**NW Natural Pre-Remedial Design Data Gaps Sampling
Gasco Sediments Site – Spring 2020
Field Change Request Form**

Project Name: Gasco Sediments Cleanup Action **Subconsultant:** Anchor QEA, LLC

Field Activity: Subsurface Sediment Sampling **Request Number:** 9

Field Change Request (FCR) Title: Nearshore Subsurface Sediment Sampling: Change of Core Sampling Depth

Figure 1
Remaining Spring 2020 Sediment Core Locations
 Field Change Request No. 9
 Gasco Sediments Cleanup Action

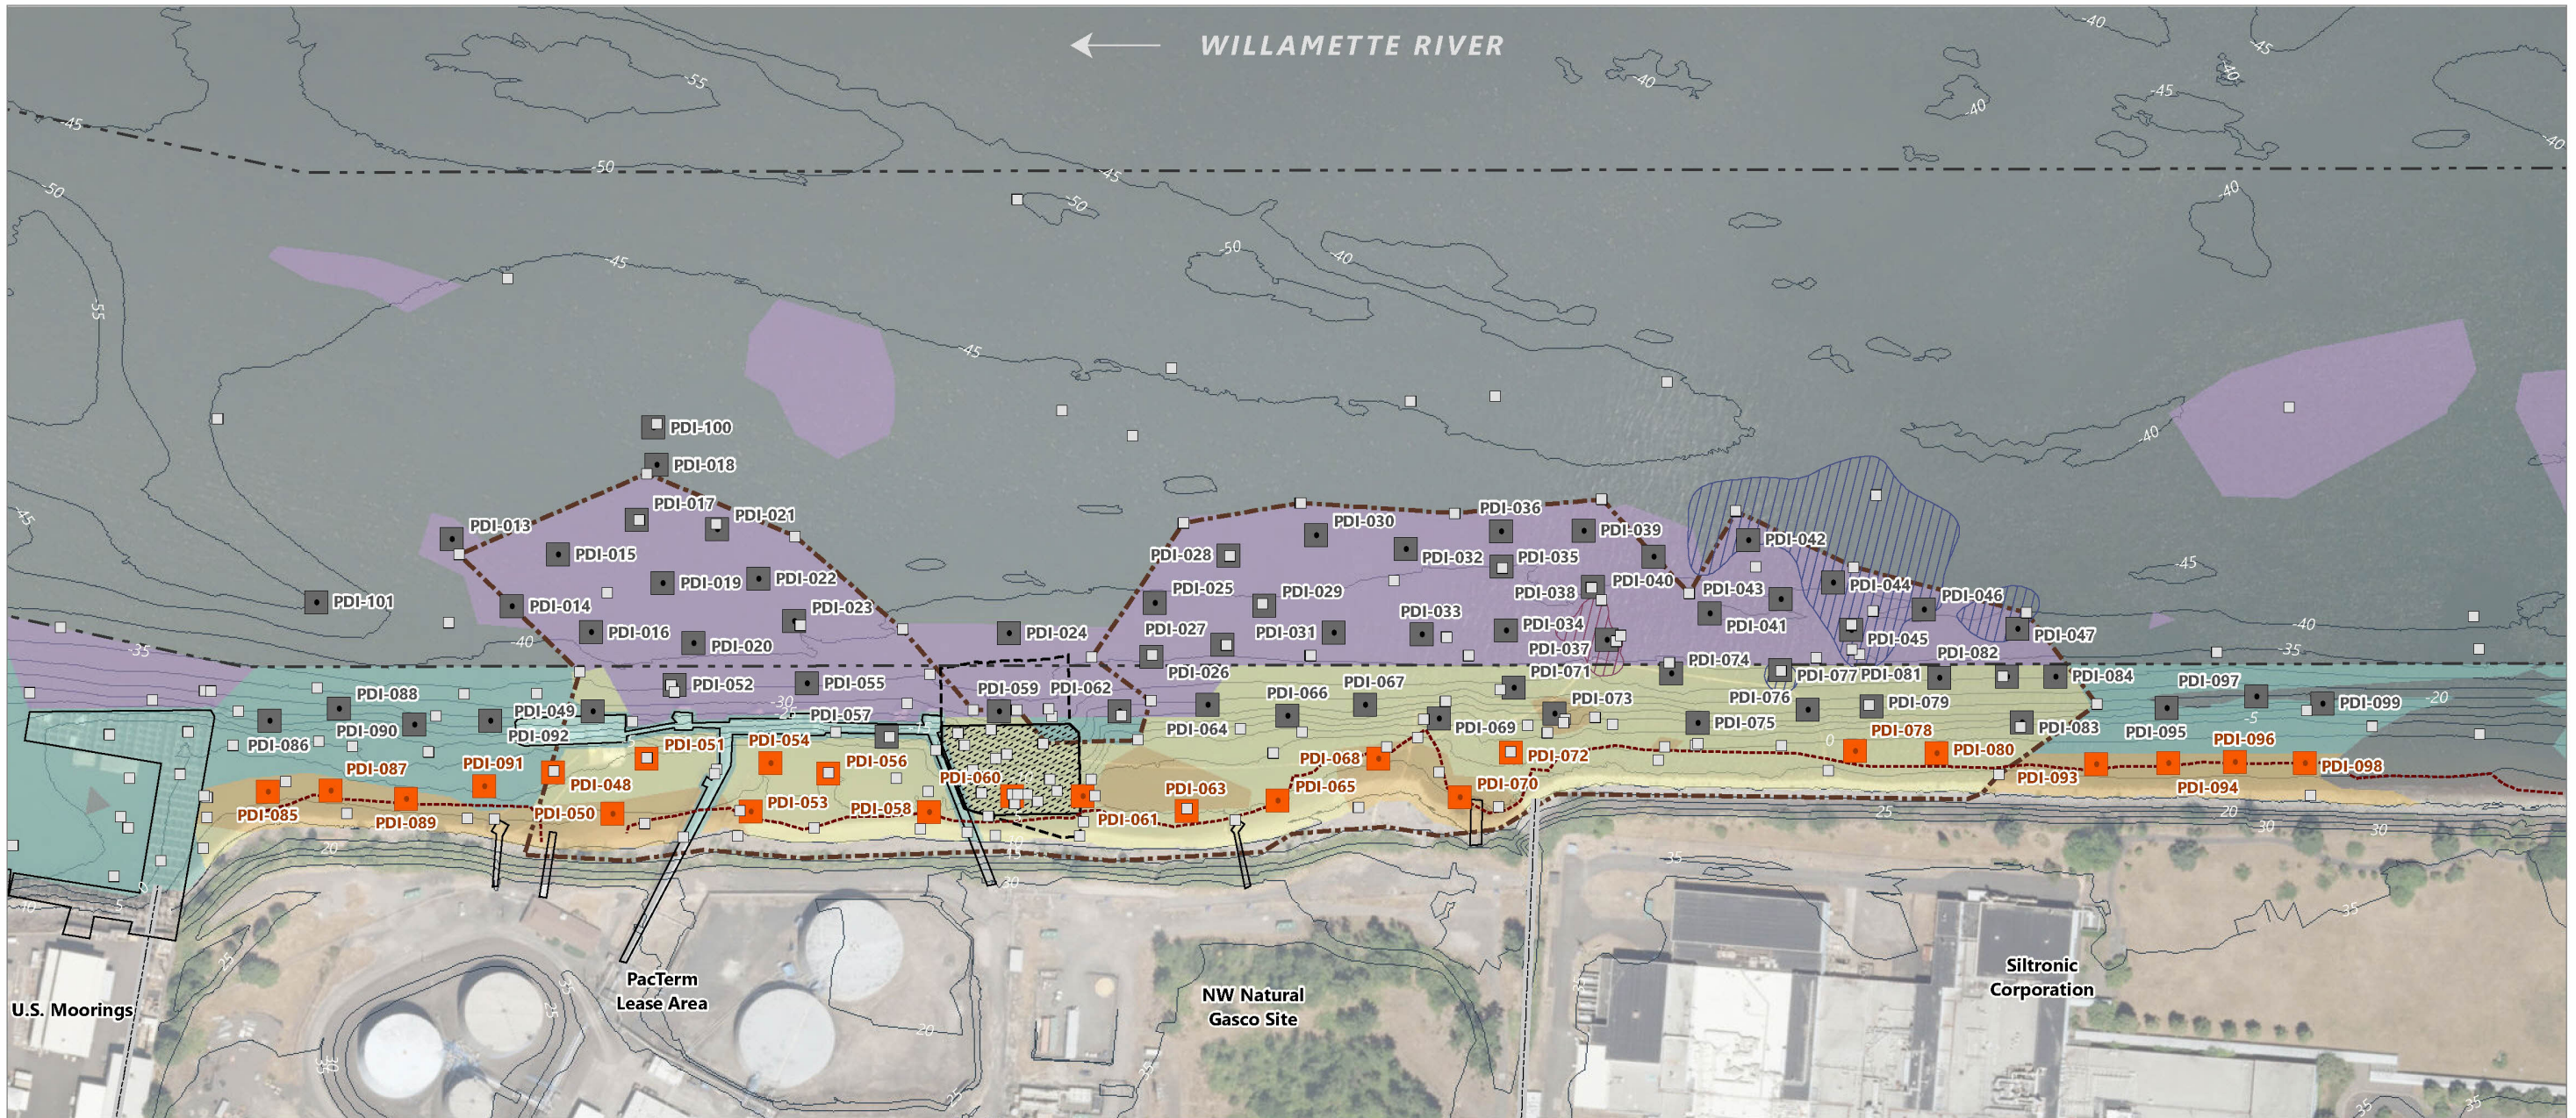
Description
<p>As discussed in Section 3.1.2 of the U.S. Environmental Protection Agency (EPA)-approved <i>Revised Pre-Remedial Design Data Gaps Work Plan (DGWP)</i>, the depth of contamination (DOC) at the Gasco Sediments Site will be determined by advancing cores to a maximum depth of 20 feet below mudline and identifying the bottom depth/elevation of subsurface sediments containing Record of Decision (ROD) Table 21 remedial action level (RAL) and principal threat waste (PTW)-highly toxic threshold exceedances.</p> <p>During the fall 2019 Pre-Design Investigation (PDI) sampling, 24 nearshore locations (Figure 1) could not be sampled using the 20-foot core sampling equipment due to insufficient river elevation for the equipment requirements. Although the river elevation during the spring 2020 PDI sampling efforts is expected to be approximately 6 feet higher than it was last fall (based on historical river level data collected by the transducers installed at the Gasco Sediments Site), our coring subcontractor has informed us that the target nearshore locations still cannot be completed safely using the 20-foot core sampling equipment. The coring subcontractor specifically rebuilt their coring gantry to accommodate the collection of more than ninety 20-foot core tubes identified in the DGWP. The rebuilt 20-foot coring gantry is approximately 4 feet longer than the coring subcontractor's standard coring gantry used for 16-foot and shorter cores. This additional depth below the vessel draft is a problem where there is insufficient water depth for maneuvering, which only occurs in the nearshore area. The coring subcontractor initially thought maneuverability would not be an issue in the nearshore area based on their previous experience at the Gasco Sediments Site and known site conditions. However, multiple coring attempts in the nearshore area during the fall 2019 PDI showed that the combination of steep nearshore slopes and limited water depth would not allow for safe maneuvering and deployment of the rebuilt 20-foot coring gantry. NW Natural does not want to relocate the stations further channelward to deeper water because that would adversely impact the data quality objectives.</p> <p>Instead, the coring subcontractor has 16-foot core sampling equipment that can be used based on the expected river elevations, allowing sampling in shallower drafts and maintaining the target nearshore locations.</p>

Recommended Change
<p>NW Natural proposes to mobilize revised core sampling equipment capable of penetrating 16 feet below mudline. This revised equipment will allow the collection of the target nearshore core locations identified in the EPA-approved DGWP.</p> <p>Although this equipment is different than the 20-foot core equipment used during the fall 2019 PDI, this revision will not affect the PDI sampling data quality objectives. Sixteen-foot cores will provide sufficient vertical chemistry data to support all remedial design evaluations identified in the EPA-approved <i>Final Pre-Remedial Basis of Design Technical Evaluations Work Plan</i>. The ROD specifies a maximum 5-foot dredge depth in the Shallow Region where PTW is not present or all PTW that cannot be reliably contained is removed to the feasible depth limit of excavation technology. Based on existing nearshore subsurface</p>

sediment data, if the DOC in this area extends below 16 feet, it is likely to extend beneath 20 feet, which is deeper than both 5 feet and the feasible depth limit of excavation technology in this area. As previously agreed with EPA, if DOC is not bounded for RAL or PTW-highly toxic threshold exceedances, NW Natural will coordinate with EPA to perform future inventory evaluations using a separate coring technology during the remedial design process. There are no changes proposed for the vertical sampling density or analytical methods.
